**Bid 643**  
**New HVAC Modernization Project for Rio Mesa High School**

**BID CLARIFICATION ADDENDUM #2**

*Bid Clarification Addendum #2*  
Attachment A  
Architect's Addendum #2  
Rio Mesa HS

Job No.  
**2841.100**  
Date  
07-13-2020  
**SQ-201**

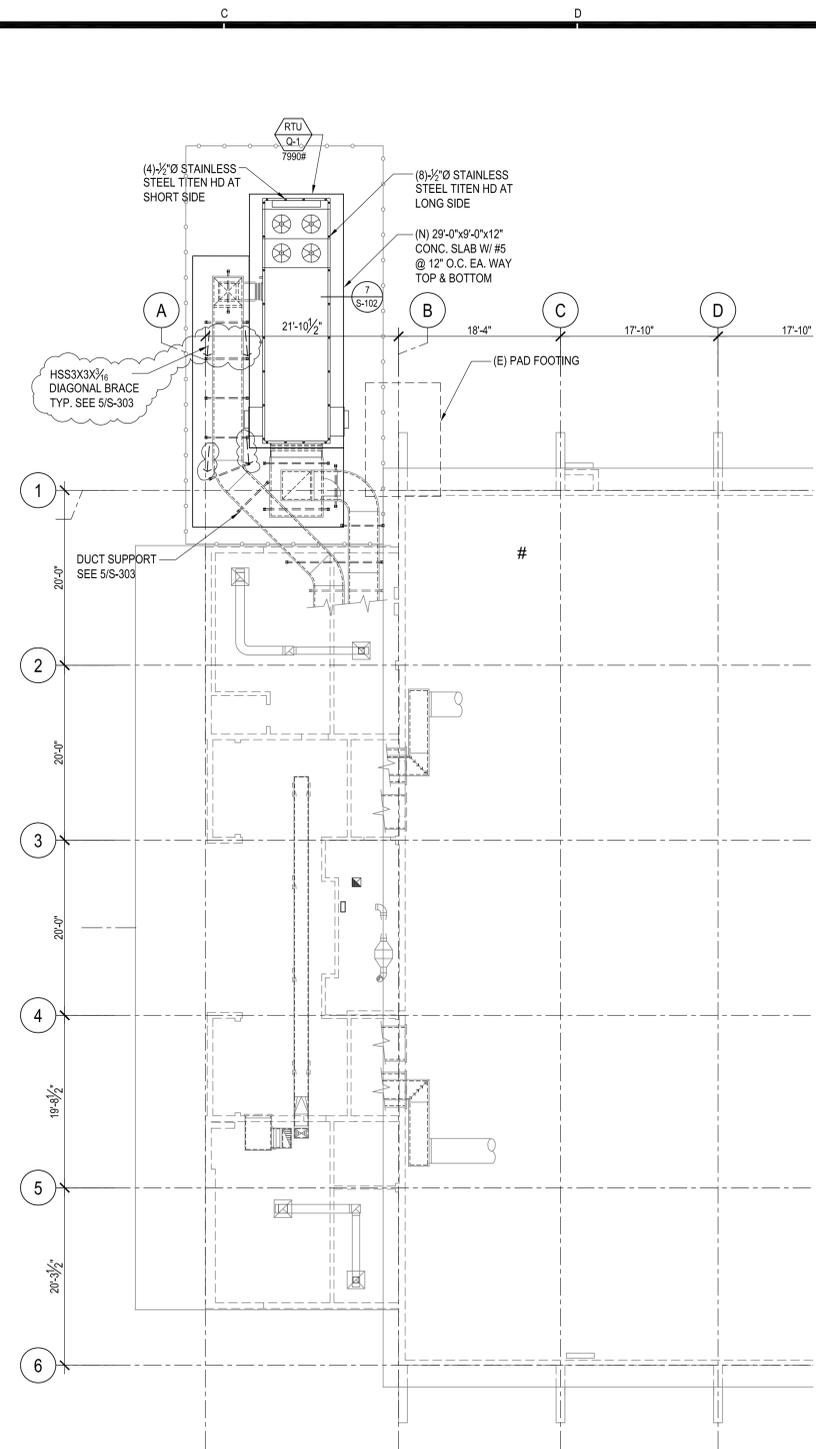
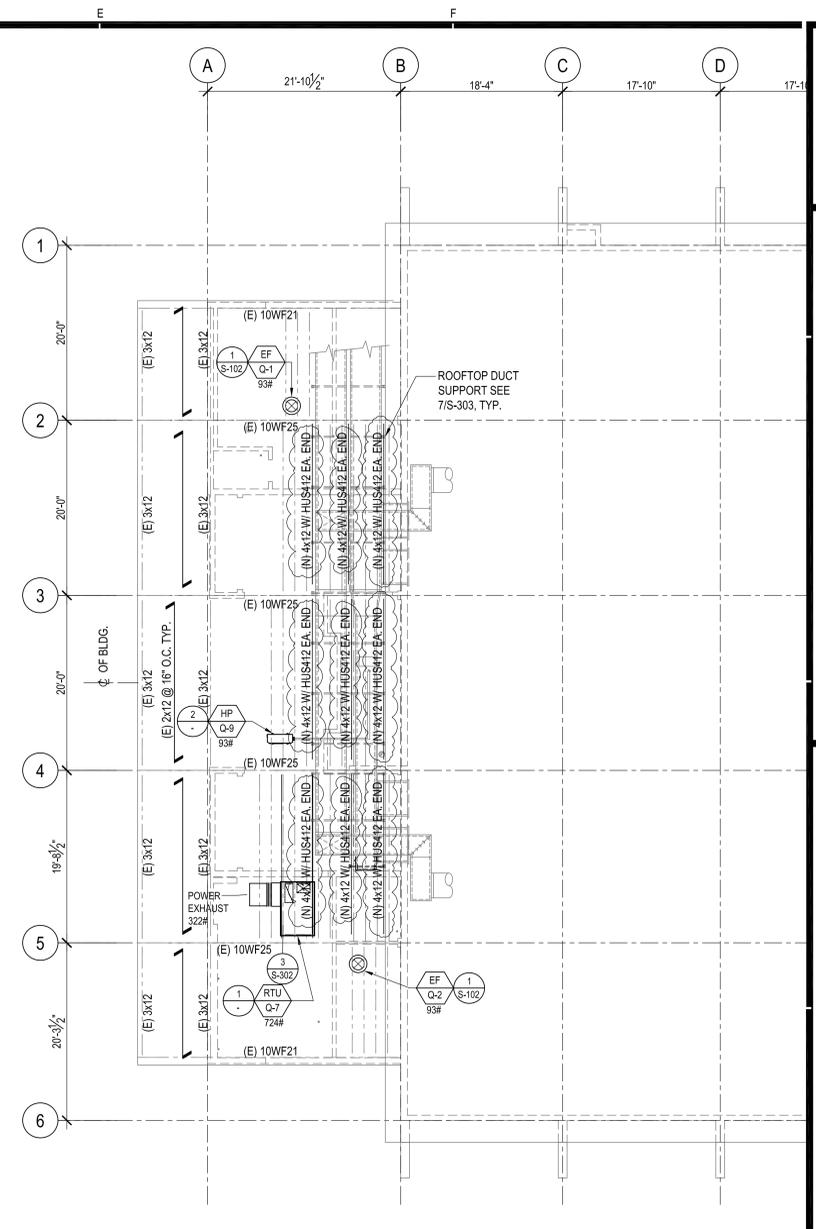
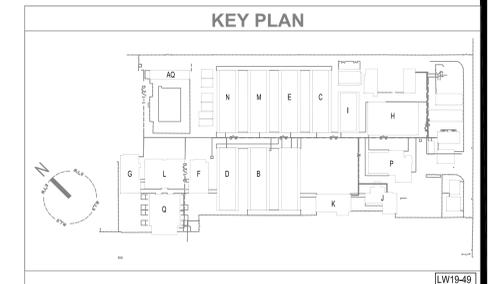
1. **Sheet SQ-201**
  - a. **Revise** sheet SQ-201 per clouded changes shown on Addendum No. 2 Sheet SQ-201.
2. **Sheet S-303**
  - a. **Revise** sheet S-303 per clouded changes shown on Addendum No. 2 Sheet S-303.

Job No: 2847.0200  
Date: 10/23/2020  
**PB-201D**

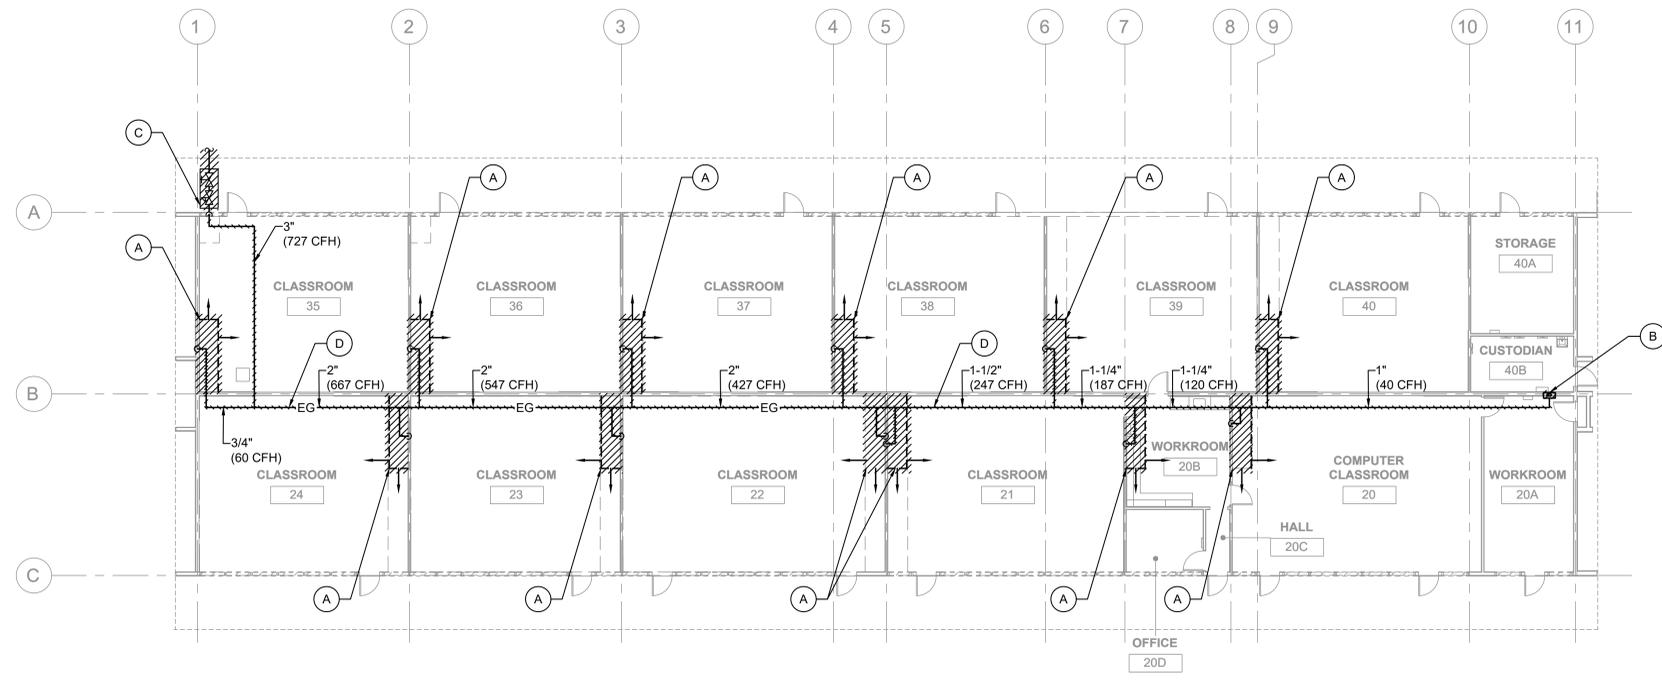
- (1)On plumbing plan sheets PB-201D, PC-201D, PH-201D, PJ-201D, PK-201D, and PP-201D the notes say to remove all existing natural gas piping but do not show any existing natural gas piping. Please show all natural gas piping that needs to be removed in order to quantify a cost for the demo inside of these buildings.
(2)Plumbing plan sheets PB-201, PC-201, PD-201, PE-201, PH-201, PI-201, PM-201, PN-201, and PAQ-201 shows the new natural gas service entrance on the opposite side of the building then where plan sheet P-101 shows the new natural gas service entering the building. Please clarify the correct location of the natural gas service entrance at these buildings.
(3)Plan sheet PK-202 shows the new natural gas piping being ran on the roof. There is no detail showing how to support and attach this new piping to the structure. Please provide a detail for the roof top pipe supports.

- 1. Sheets are updated
2. Sheets are updated
3. Attached detail 9 is to be added
